PLAT COMMITTEE

Case Number:	2023-PLT-017 (Amended) (Rehearing)
Property Address:	4900 Robison Road, 4901 Robison Road, 4929 Robison Road, 4931 Robison Road, 9290 Waldemar Road, 4908 West 86 th Street, 5000 West 86 th Street, 4007 West 93 rd Street, 4037 West 93 rd Street, 4067 West 93 rd Street, 4106 West 93 rd Street, and 4107 West 93 rd Street (<i>Approximate Addresses</i>)
Location:	Pike Township, Council District #1
Petitioner:	GDW-NW I LLC, by Kevin G. Buchheit
Zoning:	MU-1, SU-13, I-2, and I-4 (FF)
Request:	Approval of a Subdivision Plat, to be known as Northwest Park Subdivision, subdividing 292.779 acres into eight lots, with a waiver of the sidewalk requirement.
Waivers Requested:	Sidewalks
Current Land Use:	Undeveloped and Heavy Industrial Uses
Staff Reviewer:	Jeffrey York, Principal Planner

STAFF RECOMMENDATION

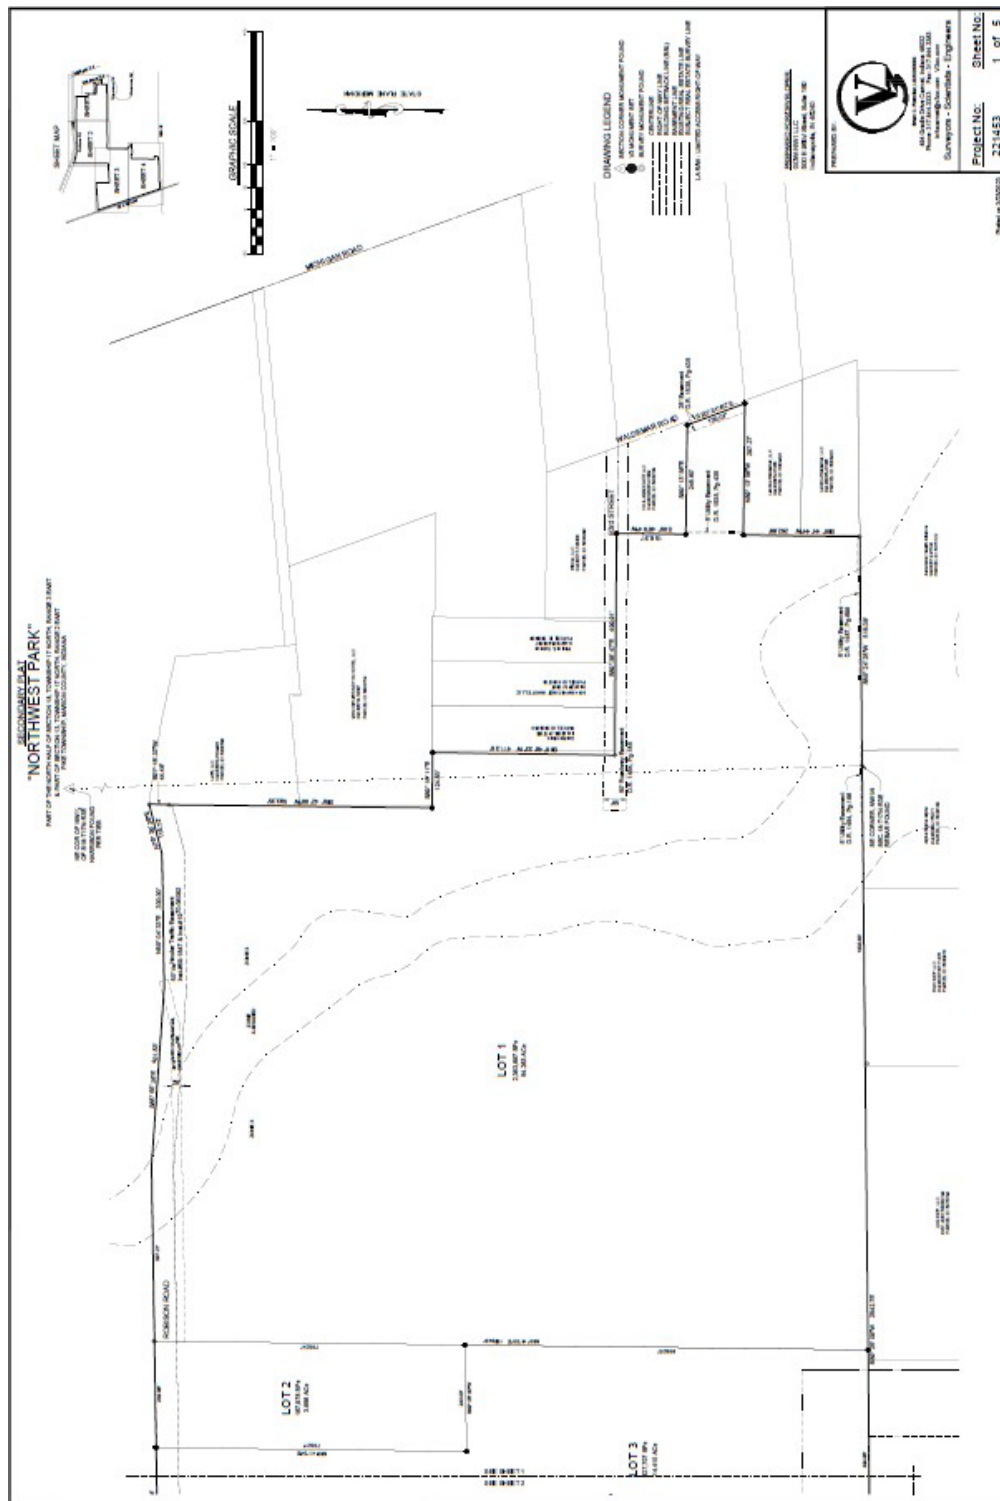
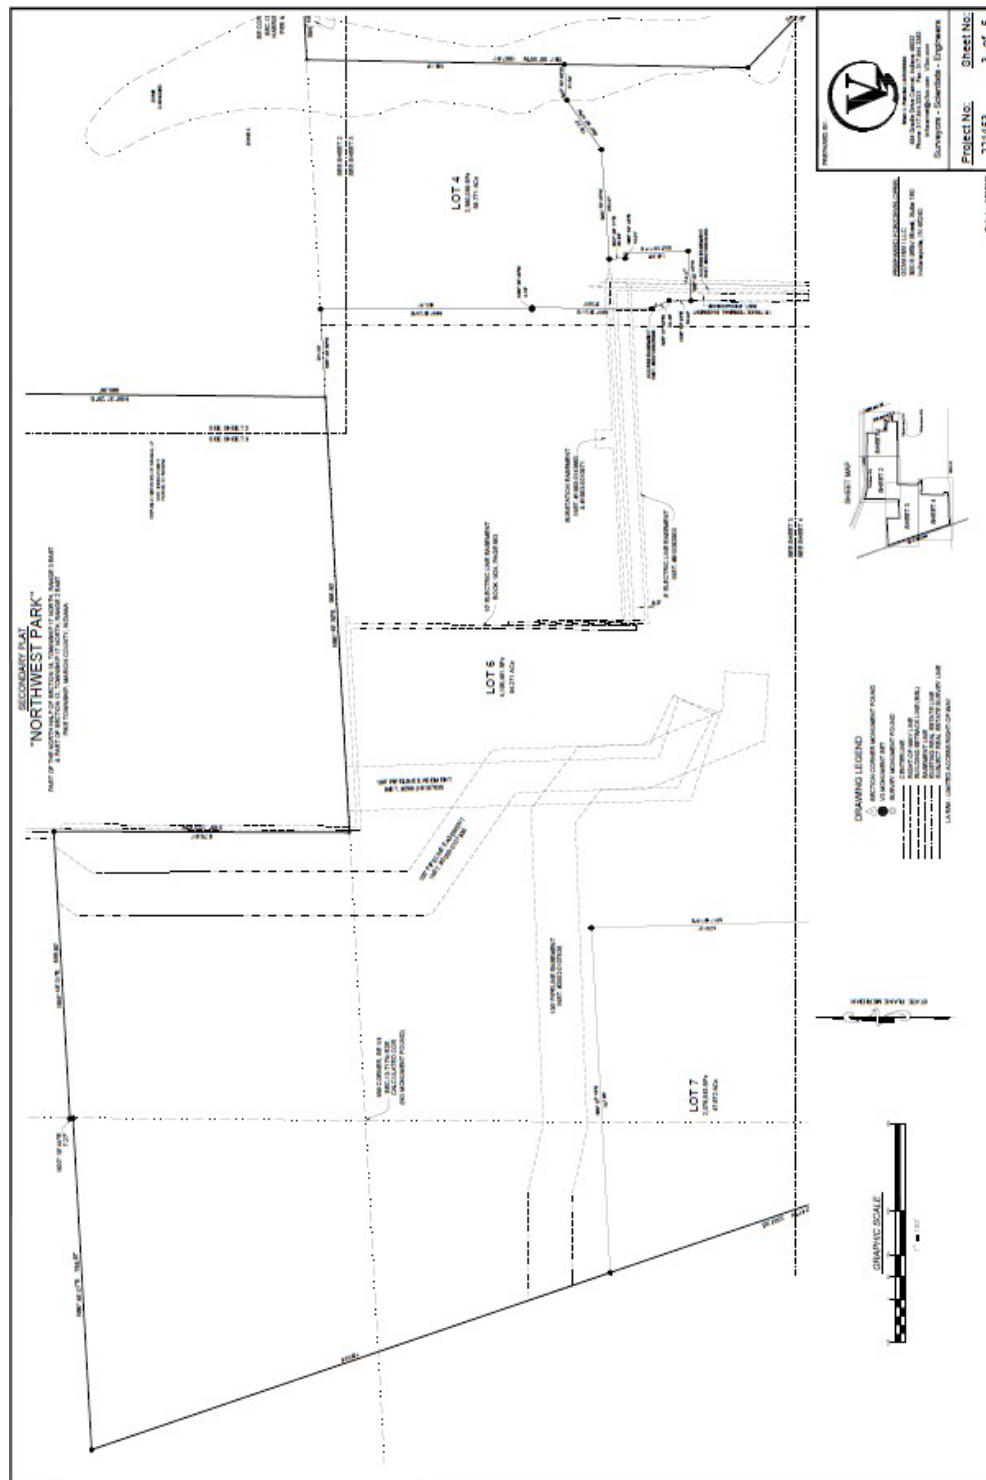
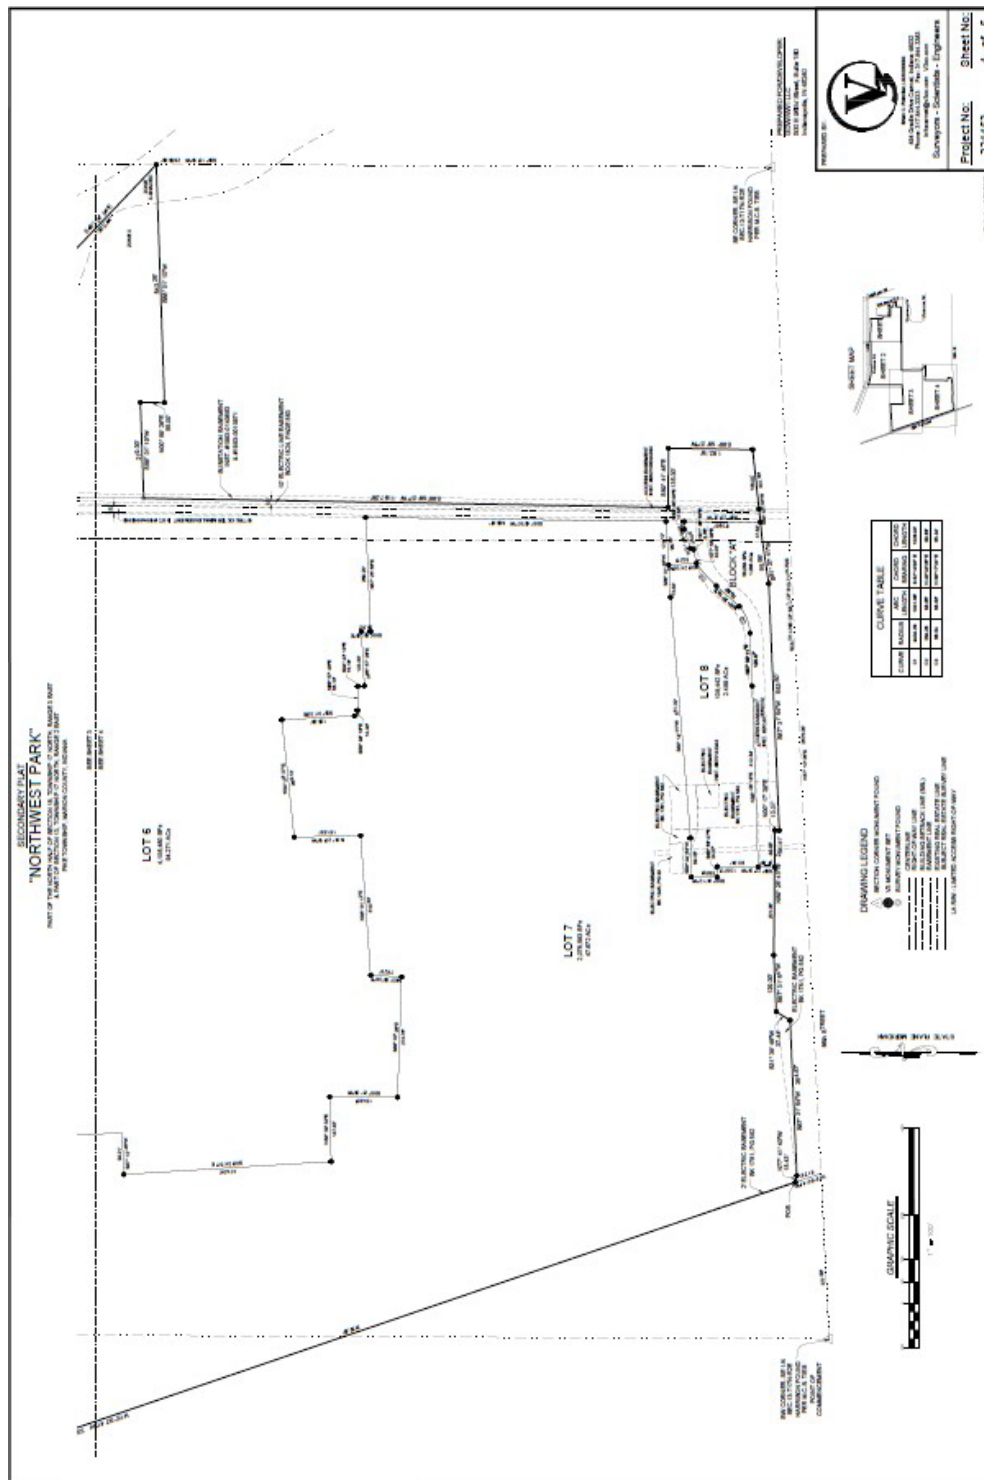
9. That the Storm Drainage Covenant (Section 741-703, of the Consolidated Zoning and Subdivision Ordinance) be affixed to the final plat prior to recording.
10. That the plat restrictions and covenants, done in accordance with the rezoning commitments, be submitted prior to recording the final plat.
11. That all the standards related to secondary plat approval listed in Sections 741-207 and 741-208 of the Consolidated Zoning and Subdivision Ordinance be met prior to recording the final plat.
12. That the request to waive sidewalks be denied.

Sidewalks do not exist along any rights-of-way that abut this Plat. Sidewalks would be required along two areas that abut public streets: Lot 1, along Waldemar Road and Lots 7 and 8, along 86th Street. The portion of Lot 1 that abuts Waldemar Road is approximately 139 feet in length. The portion of Lots 7 and 8 that abut 86th Street is approximately 1,670 feet in length. On a site visit, staff noted that there were no physical limitations of the land that would prevent the installation of sidewalks along either frontage. Additionally, the petitioner did not submit any evidence that there would be extreme difficulty that would prevent the installation of sidewalks. The petitioner did submit Findings of Fact, which are below.
